Changes highlighted are against drawing 'Unit 2 Roof Plan Drg No: 22113 P2006 Rev: D' approved on 5 May 2022 (Application No. 22/00430/FUL)

DZ3 Hinckley Park, Avery Way

Unit 2 - NMA App - Roof Plan

1 NMA App - Roof Plan
1 : 200

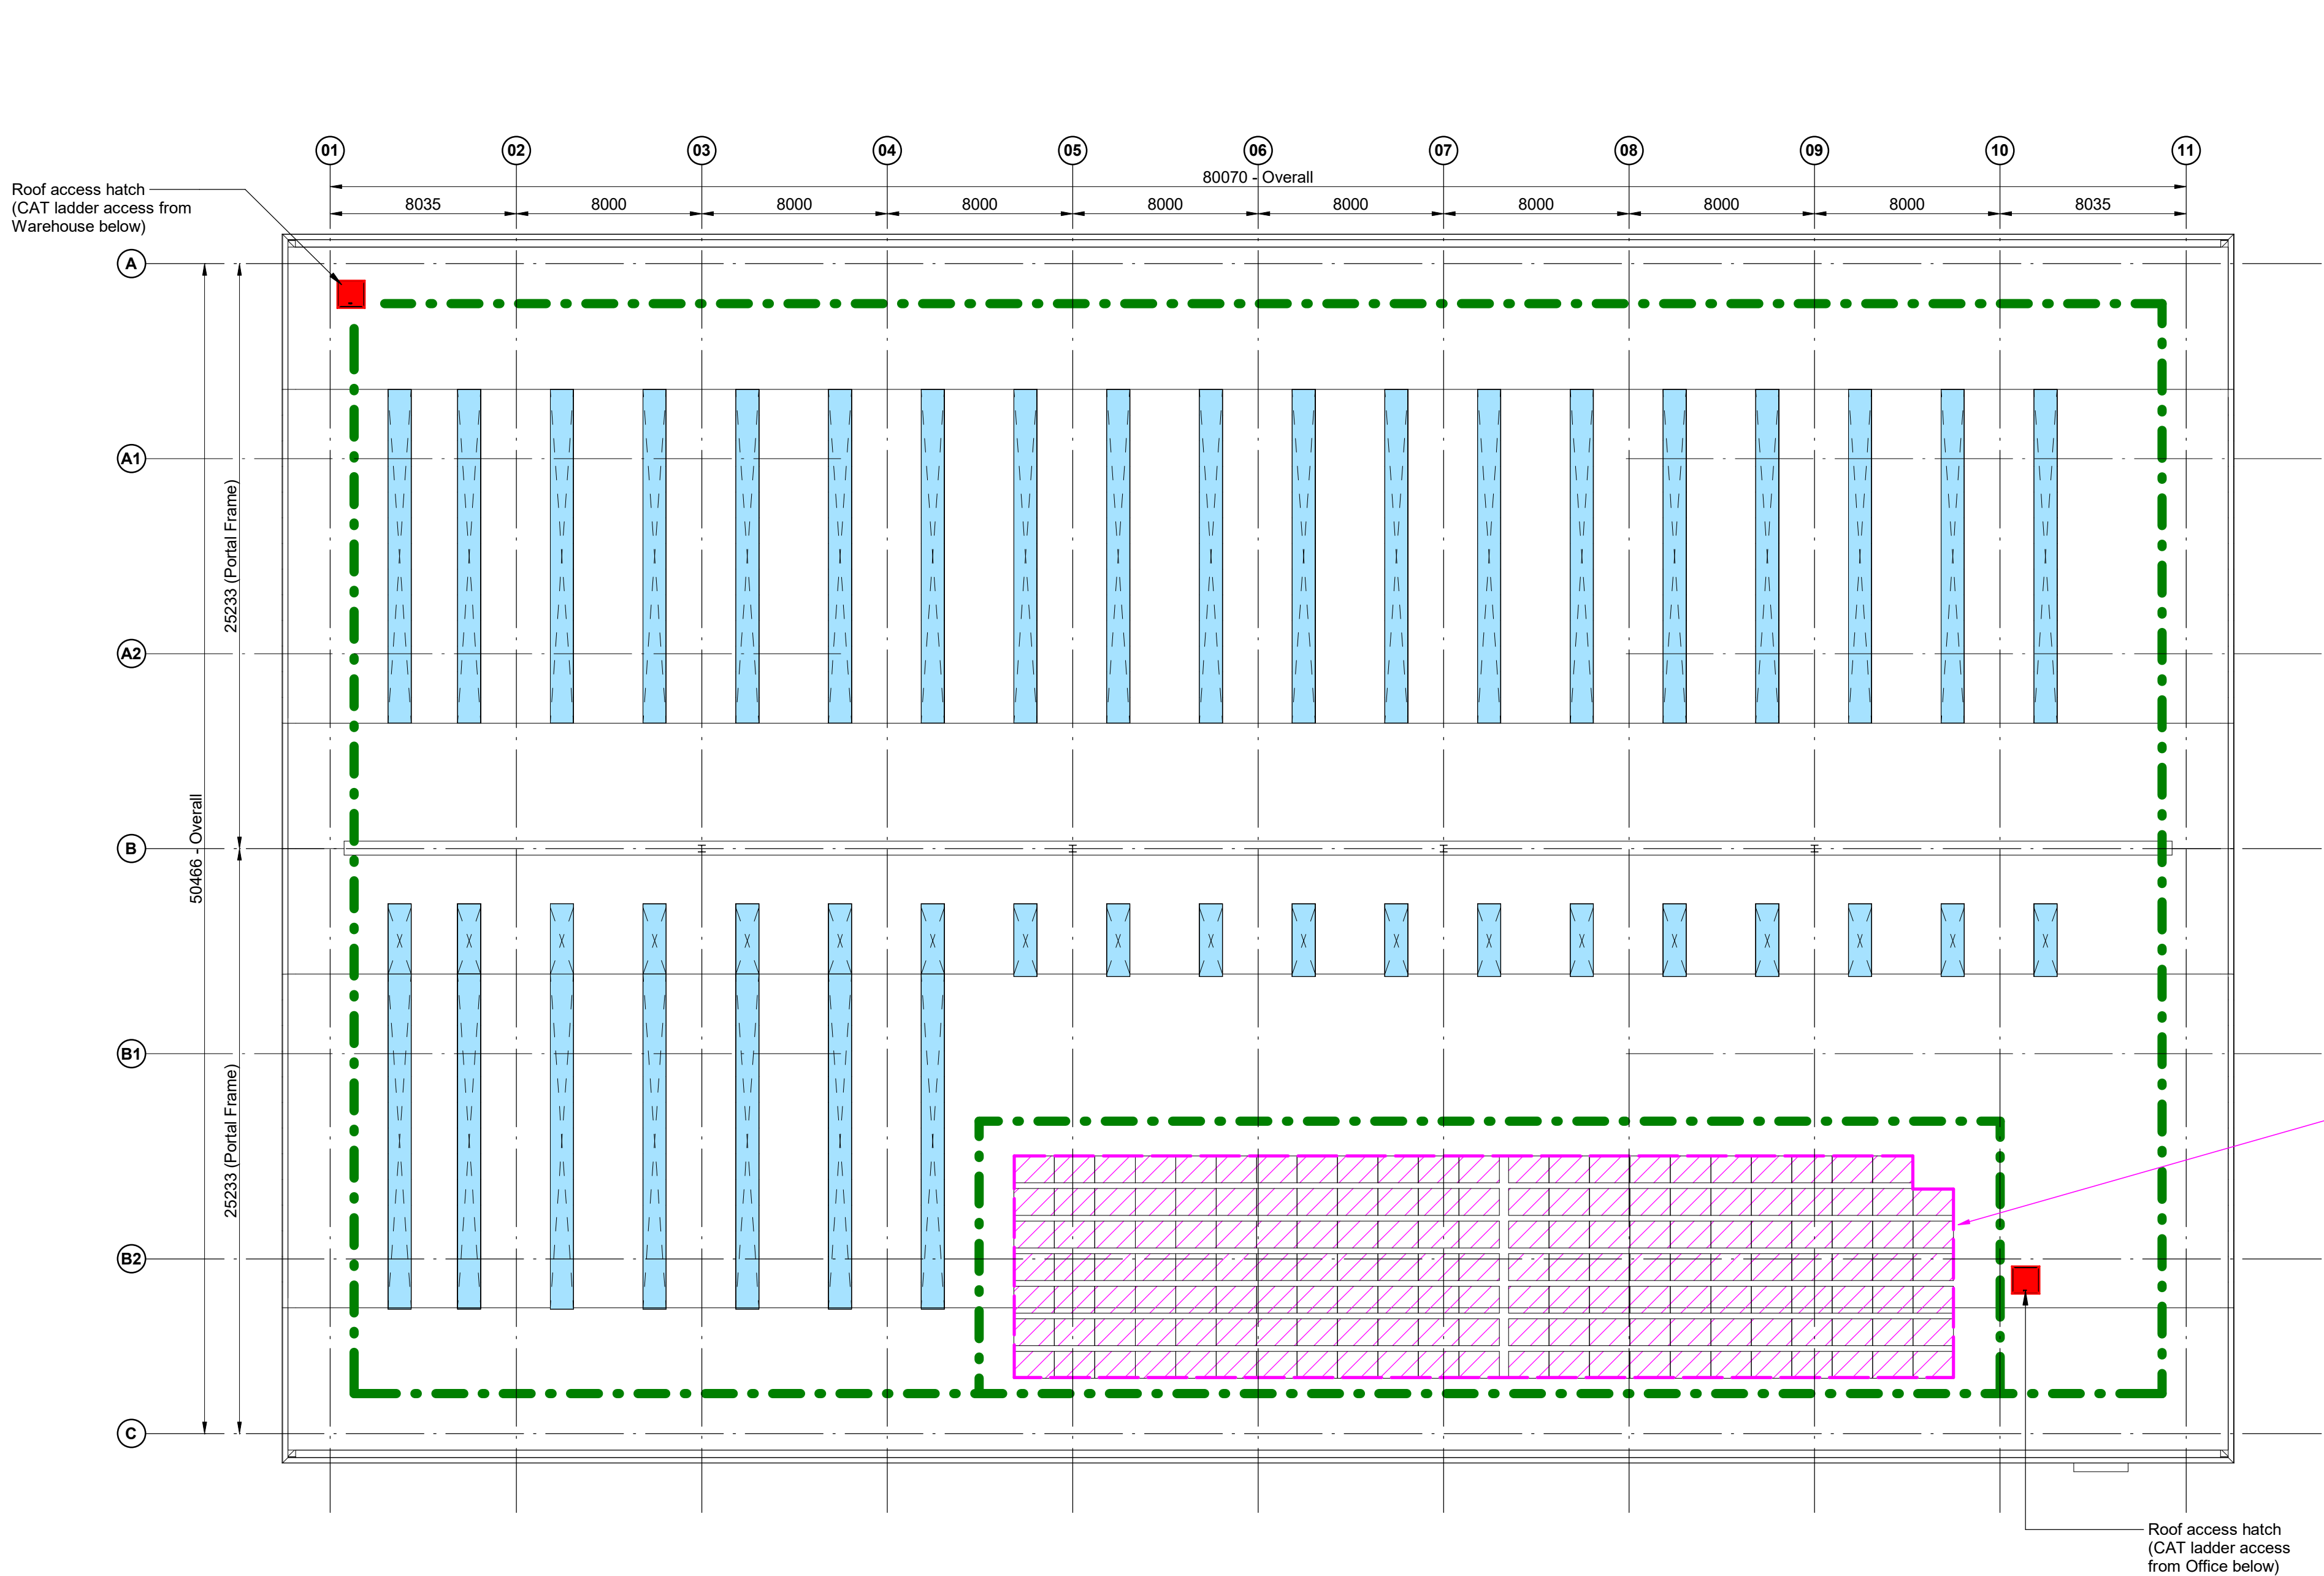
01 - Proposed PV layout indicated.

Independent Energy Group proposed PV Layout - Option 1
160 x 140w Photovoltaic Panels Providing a 65.6kWp System.
Rows to have 250mm inbetween to avoid shadowing.
